A4 Bath to Bristol consultation response

Keynsham section | Walk Ride Bath and North East Somerset | 20 September 2026

Figure 2d Hicks Gate Joint Masterplan, May 2026, Figure 8, masterplan maximum scenario (printed page 15). Source: AECOM / CBRE for WECA, Bristol City Council and B&NES. Original legend retained. Proposed development and transport infrastructure are indicative. [9]

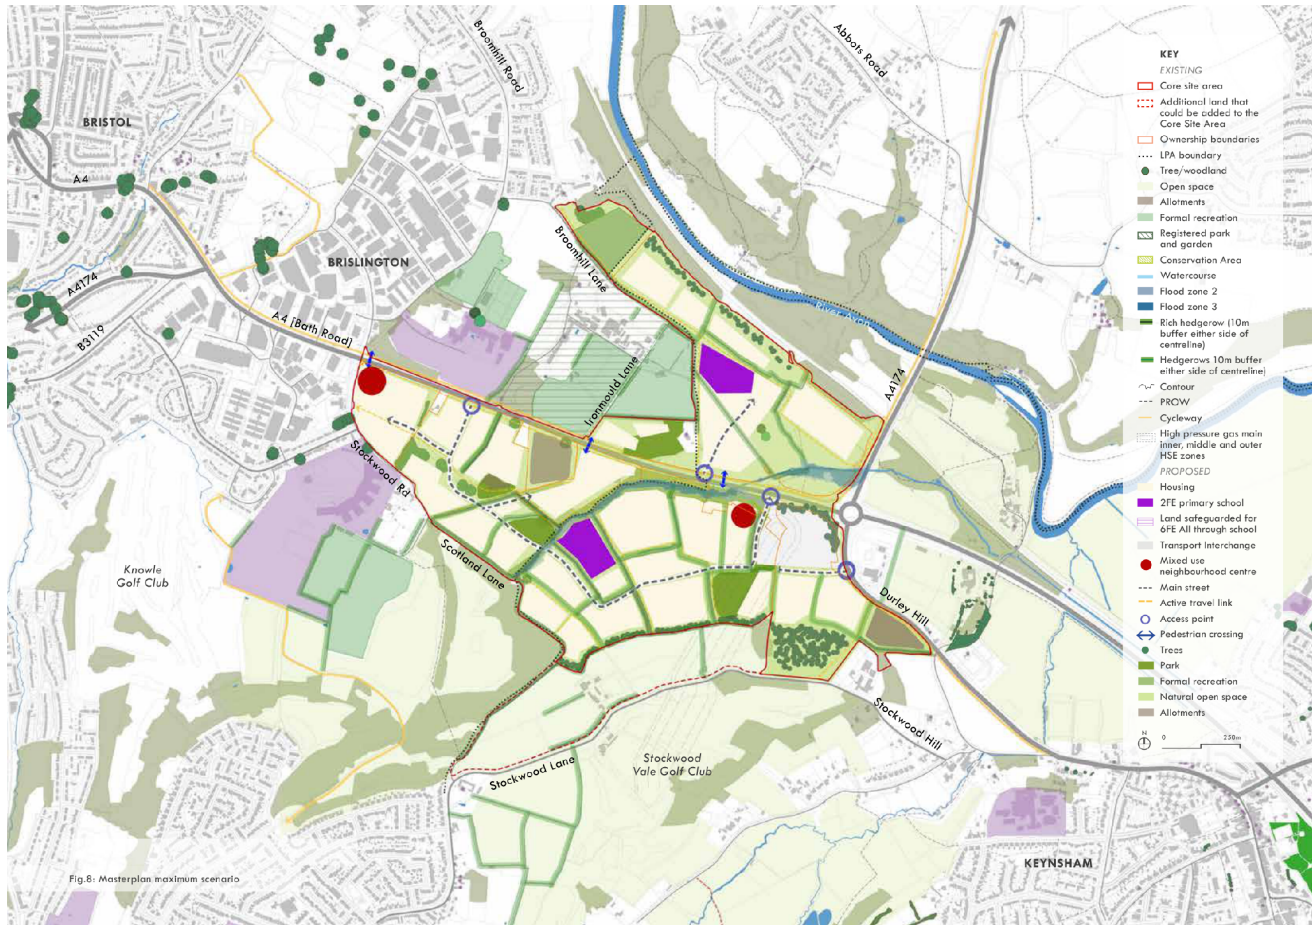
Hicks Gate roundabout sits towards the eastern side of the plan, with the A4 bypass continuing towards Keynsham. The proposed transport interchange is south-west of the roundabout. WRB asks for the development's walking, wheeling and cycling routes to connect continuously through this junction to the bypass path and the Pool Barton-Station Road station approach.

The masterplan does not include a designed connection to Keynsham station. Agree the station link, bus services and delivery responsibilities across the development and corridor schemes.

Figure 2a The new Memorial Park path meets the proposed bypass stops. Assess the complete approach through the park, beyond this short connection. Source: WECA consultation drawing reproduced in the Bristol Cycling Campaign draft.

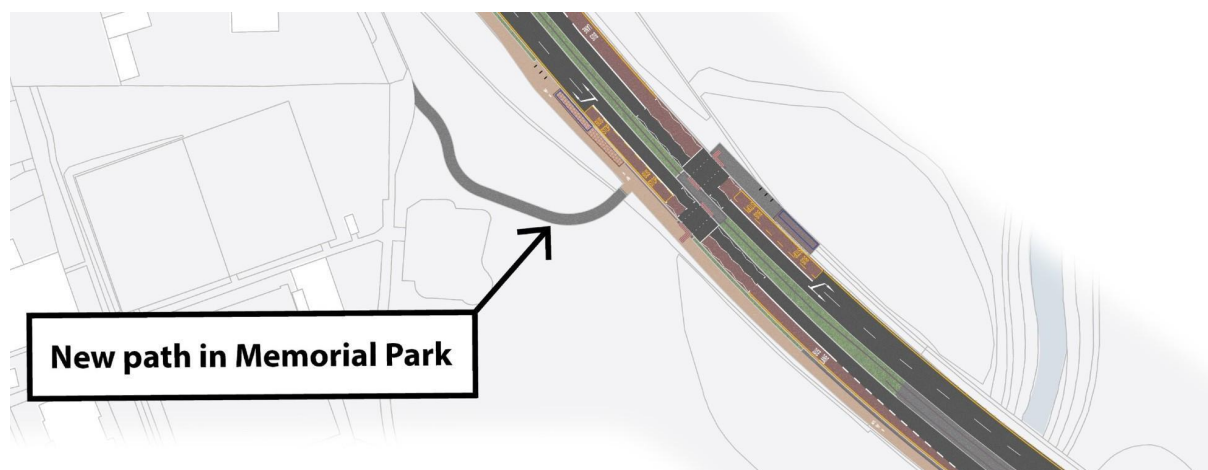
WRB's local assessment is that some journeys would involve five minutes or more walking alone through isolated parts of the park. This is an estimate for the wider approach, not the length of the proposed 70 metre access path. Publish walking times from relevant entrances and neighbourhoods, including slower walking and wheeling speeds, and assess conditions throughout the hours buses operate.

Fear of harassment or being unable to find help can make a route unusable even where its surface and gradient are accessible. Lighting helps people see, but does not by itself create overlooking, activity or nearby assistance. WRB does not consider a park-dependent approach an acceptable principal route to these stops late at night.

Figure 3 WRB illustrative concept for Station Road access, showing potential lifts and ramps to the bypass stops. Not to scale or council approved. Road layout, stop positions, gradients and structural works are illustrative and require assessment.

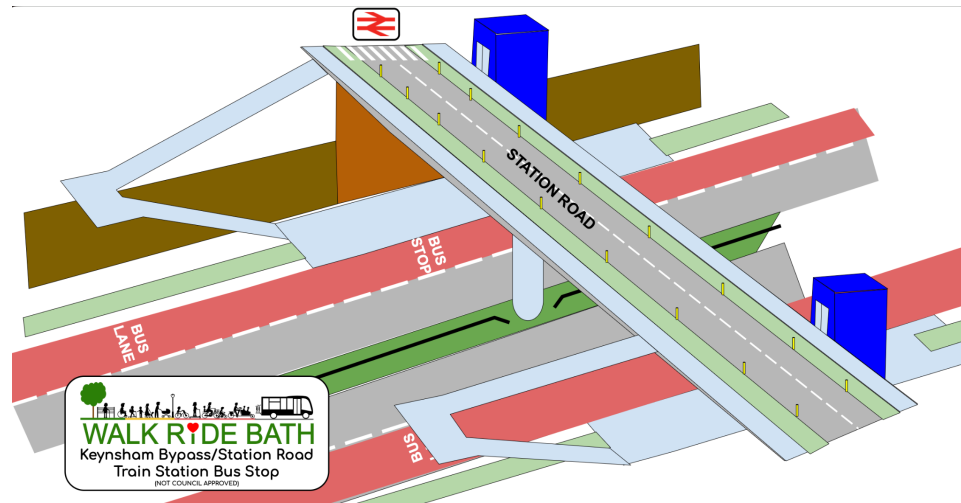
Assess passenger lifts between Station Road and the bypass bus stops, either alongside ramps or where a direct ramp cannot fit. Provide suitable lift dimensions, doors and approaches for wheelchairs, mobility scooters and any cycles using that connection. Stairs may supplement step-free access but cannot replace it.

For the constrained stop location beside the existing retaining wall, allow for structural works to create space for the stop, boarding area and access. A lift reduces the length needed for a ramp, but does not remove this requirement. Survey the wall, foundations and available width, and assess alterations, replacement or an independently supported structure. Keep the southern walking, wheeling and cycling path clear throughout.

Figure 6 Hicks Gate proposals, including the new crossing south of the roundabout. Source: WECA consultation drawing reproduced in the Bristol Cycling Campaign draft.

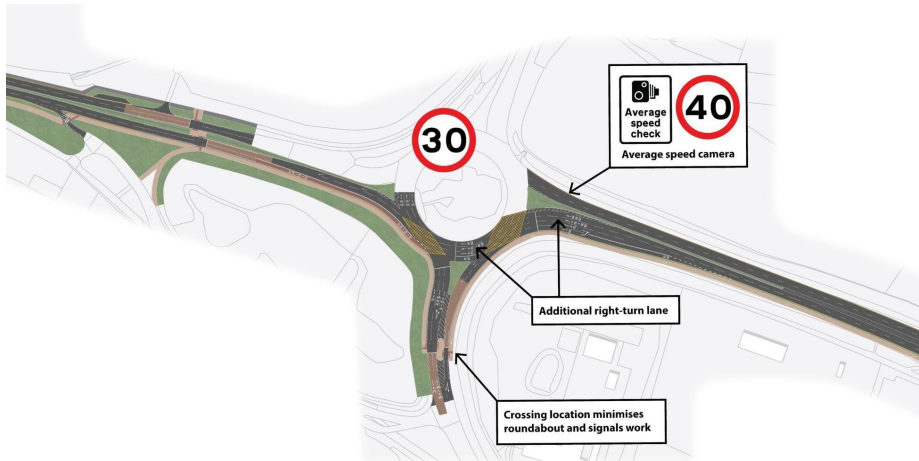
We support the 30 mph limit, improved crossings and wider waiting area. Place the new A4175 crossing as close to the roundabout as safely practicable and publish the extra distance imposed on each walking, wheeling and cycling movement. Avoid an unnecessary stagger and connect all approaches clearly. [3]

Treat these works as a step towards a fully accessible junction. Safeguard future improvements around Hicks Gate and investigate connections towards the Avon corridor, subject to land, levels and environmental assessment.

Figure 9 The Station Road connections also serve the wider network. Onward links need coordinated design and delivery; this diagram does not imply that future schemes are funded.

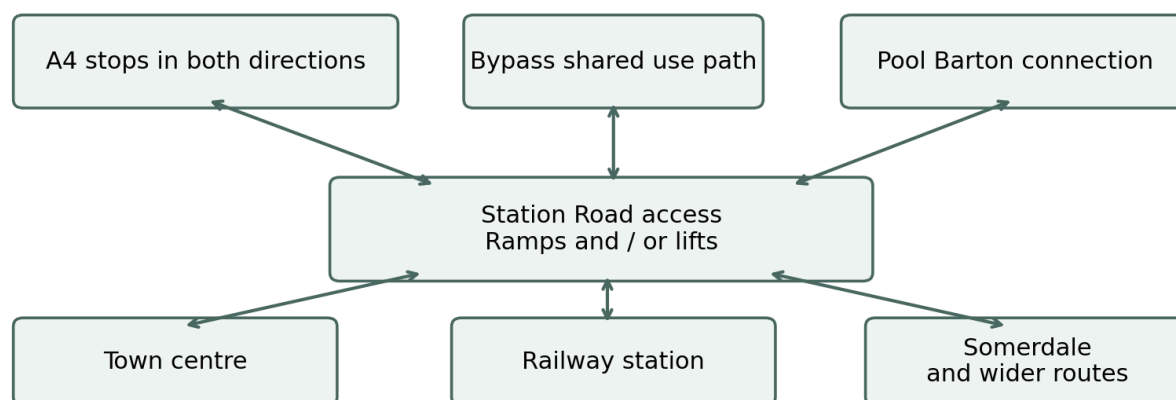
The bypass should support journeys to work, education, shops and public transport. Plan its connections alongside the proposed Keynsham-Willsbridge route towards Bitton and the emerging Somerdale and Avon network. These wider links should be safeguarded without treating their delivery or funding as certain. [6, 7]
